HITACHI SEMICONDUCTOR TECHNICAL UPDATE

DATE	23 August 2000	No. TN-SH7-246A/E			
THEME	SH7750 Section23 Electrical Characteristics on SH7750 Series Hardware Manual				
CLASSIFICATION	☐ Spec. change ☐ Limitation on Use ☐ Supplement of Documents				
PRODUCT NAME	HD6417750, HD6417750S				
REFERENCE	SH7750 Series Hardware Manual	Effective Date: Eternity			
DOCUMENTS		Lot#: All

DATE	23 August 2000	No.	TN-SH7-247A/E		
THEME	SH-4 Handling of Reserved Pin and CA pin				
CLASSIFICATION	☐ Spec change ☐ Limitation on Use ☐ Supplement of Documents				
PRODUCTNAME	HD6417750, HD6417750S, HD6417751			Lot No.etc.	All
REFERENCE DOCUMENTS	SH7750 series Hardware Manual SH7751 Hardware Manual	Re	v.	EffectiveDate	Eternity
		1 - 4	4	From

Figure 23.13 Control Signal Timing

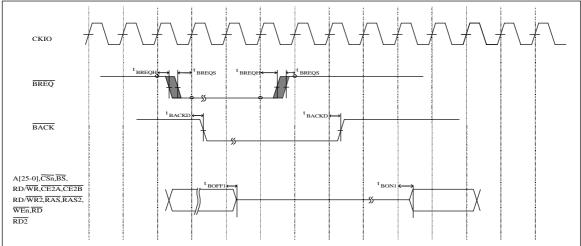
- Following Figure 23.13 of SH7750 series Hardware Manual(Section23 Electrical Characteristics) is changed.
- 1-1. 23.3 AC Characteristics 23.3.2 Control Signal Timing Figure 23.13 is corrected as bellow.
